Access Compliance Report

Public Rights-of-Way

(Curb Ramps)

Intersection ID: 12975	Main Street: HICKORY GROVE RD	Cross Street: HOBBS HILL DR	Location: NE
ADA ID: F2FF2226378F	Ramp Type: PerpDiag	Initial Pass/Fail: Fail	Overall Compliance: No
		Severity Score: 12.5

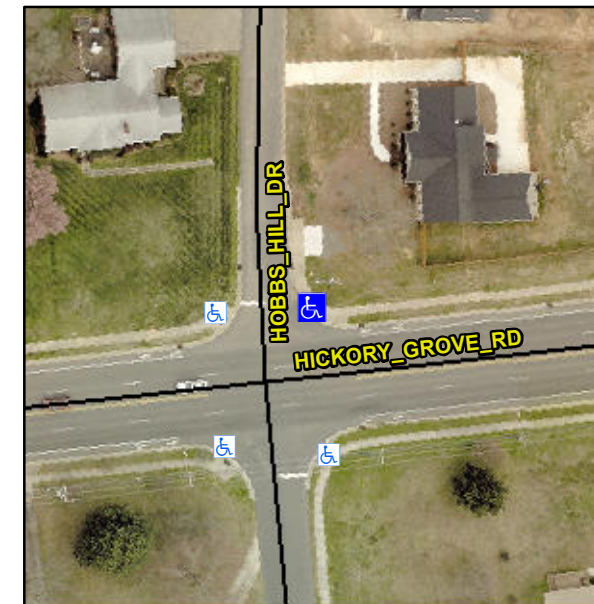
Not Found, R304.2.2

Compliance	Description	Data	Compliance	Description	Data
N/A	Ramp Length (in)	70.5	No	Ramp Slope (%)	8.7
Yes	Ramp Width (in)	49.0	Yes	Ramp XSlope (%)	1.2
N/A	Flare Type LT	N/A	N/A	Flare Type RT	N/A
N/A	Flare Slope LT (%)	N/A	N/A	Flare Slope RT (%)	N/A
N/A	Flare Traversable LT?	N/A	N/A	Flare Traversable RT?	N/A
N/A	Landing Length (in)	N/A	N/A	DWS Provided?	N/A
N/A	Landing Width (in)	N/A	N/A	DWS Contrast?	N/A
N/A	Landing Slope (%)	N/A	N/A	DWS Length (in)	N/A
N/A	Landing X Slope (%)	N/A	N/A	DWS Full Width?	N/A
N/A	Landing Curb? (Y/N)	N/A	N/A	DWS Offset (in)	N/A
N/A	Shared Landing?	N/A			
N/A	Gutter Ponding?	N/A	N/A	Gutter Slope (%)	N/A
N/A	Gutter Lip Ht (in)	N/A	N/A	Gutter X Slope (%)	N/A
N/A	Painted X Walk1?	No	N/A	Painted X Walk2?	No
	X Walk 1 Direction	To W		X Walk 2 Direction	To S
N/A	X Walk 1 Width (in)	N/A	N/A	X Walk 2 Width (in)	N/A
	X Walk 1 Slope (%)	2.6		X Walk 2 Slope (%)	2.7
	X Walk 1 X Slope (%)	1.1		X Walk 2 X Slope (%)	1.5

Remove & Replace Curb Ramp With Two New Directional Ramps or Equivalent.
